SUBJECT: Yuba River Development Project
FERC Project No. 2246-058 - California
Response to CDFW's Request for
Narrows 2 Power Intake Entrainment Study

This letter provides the Yuba County Water Agency's (YCWA or Licensee) comments on the California Department of Fish and Wildlife's (CDFW) July 3, 2013 request for a new study in support of YCWA's relicensing of its Yuba River Development Project, Federal Energy Regulatory Commission (FERC) Project Number 2246 (Project).

Figure 3. Photos showing configuration of discharge and typical operations of Narrows 2 Powerhouse, Narrows 2 Powerhouse Partial Bypass and Narrows 2 Powerhouse Full Bypass.

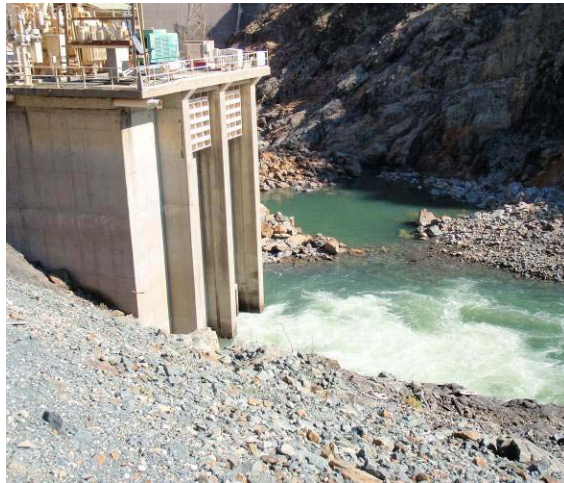
As an alternative to placing nets across the entire tailrace to capture Englebright Dam spill, one could place nets at the three outlets from the Narrows 2 Power Tunnel: 1) the Narrows 2 Powerhouse, which has a maximum discharge capacity of 3,400 cfs; 2) the Narrows 2 Partial Bypass, which has a maximum discharge of 650 cfs; and 3) the Narrows 2 Full Bypass, which has a maximum discharge of 3,000 cfs. However, the configuration and flows through these outlets would make deploying and retrieving entrainment sampling nets, as well as efficiently sampling fish (i.e., nets large enough to withstand the flow and not damage fish), very difficult. Figure 3 shows the locations and typical operations of these facilities.

Besides these logistic issues, which YCWA believes in and of themselves makes CDFW's requested study not feasible, other questions can be raised regarding the study protocol. For instance, CDFW has provided no rationale for its sampling phases and frequencies.
